Process Sheet

Customer :	CU-DAR001 Dart Helicopters Services	Drawing Name :	BASKET RIB
Job Number :	48573		
Estimate Number :	10402		
P.O. Number :		Part Number :	D31661
This Issue :	15/06/2009	S.O. No. :	
Prsht Rev. :	NC	Drawing Number :	D3166 REV.A2
First Issue :	/ /	Project Number :	N/A
Previous Run :	48491	Drawing Revision :	A2
	Type :	Material :	
	LARGE FAB ASSY	Due Date :	18/06/2009
Written By :		Qty:	12
Checked & Approved By :	<u>JULIA DAWSON</u>	Um:	Each
Comment :	Est. A 02.08.23 New issue KJ Est. B 08.12.05 Updated bending program on step 3 per NCR W/O43165 KJ Verified by: EC Est Rev:C 09-01-23 as per DEO D3166-A2 DD verified by:EC

DRAWING NO. D3166	TITLE BASKET HOOP	REV A1	DART AEROSPACE LTD ENGINEERING ORDER		D.E.O. NO. D3166-A-2	SHEET NO. 1 OF 1	SCALE NTS
DRAWN AJ5	CHECKED [Signature]	MFG. APPR. [Signature]	APPROVED [Signature]		DE APPR. [Signature]		
DATE 08.12.11	DATE 08.12.15	DATE 08/12/15	DATE 08/12/16		DATE 08.12.16

DESIGN #	DRAWN BY CP	DART AEROSPACE LTD HAWKESBURY, ONTARIO, CANADA	
CHECKED #	APPROVED #	DRAWING NO. D3166	REV. A SHEET 1 OF 1
DATE 02.07.10		TITLE BASKET HOOP	SCALE NTS
A	02.07.10	NEW ISSUE	
A1	04.04.08	38+-1 WAS 36.0

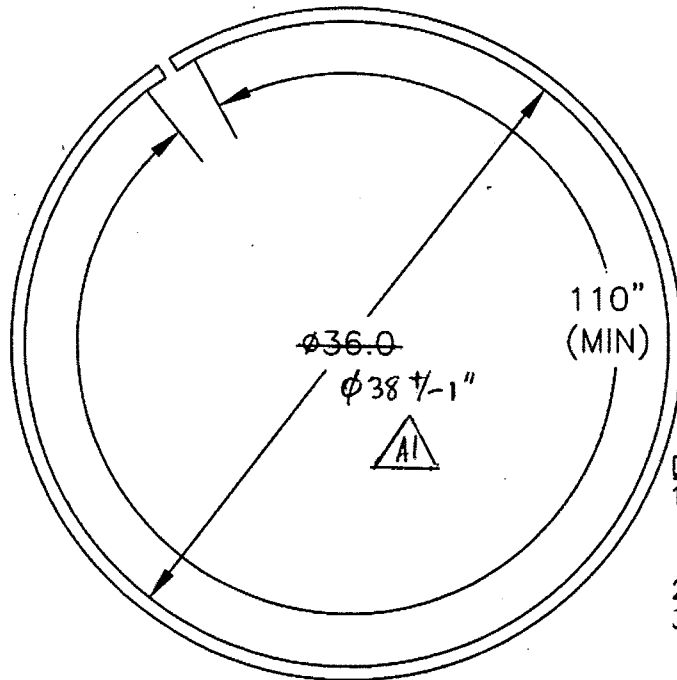
1) MODIFY MATERIAL NOTE FOR D3166-1 AS SHOWN:

WAS:

1) MATERIAL: AISI 304/316 SS SQUARE TUBING,
0.75" x 0.75" x 0.063 WALL, 60.00" LONG
(REF DART SPEC. M304TS0.750W.063)

2) MODIFY MATERIAL NOTE FOR D3166-3 AS SHOWN:

WAS:

1) MATERIAL: AISI 304/316 SS SQUARE TUBING,
0.75" x 0.75" x 0.063 WALL, 120.00" LONG
(REF DART SPEC. M304TS0.750W.063)

REASON: SEE PAR 08-005

IS:

1) MATERIAL: AISI 304/316 SS, 3/4 X 3/4 X 0.065 WALL SQUARE TUBING,
60.00" LONG
REF. DART SPEC M304TS0.750W.065

IS:

1) MATERIAL: AISI 304/316 SS, 3/4 X 3/4 X 0.065 WALL SQUARE TUBING,
120.00" LONG
REF. DART SPEC M304TS0.750W.065
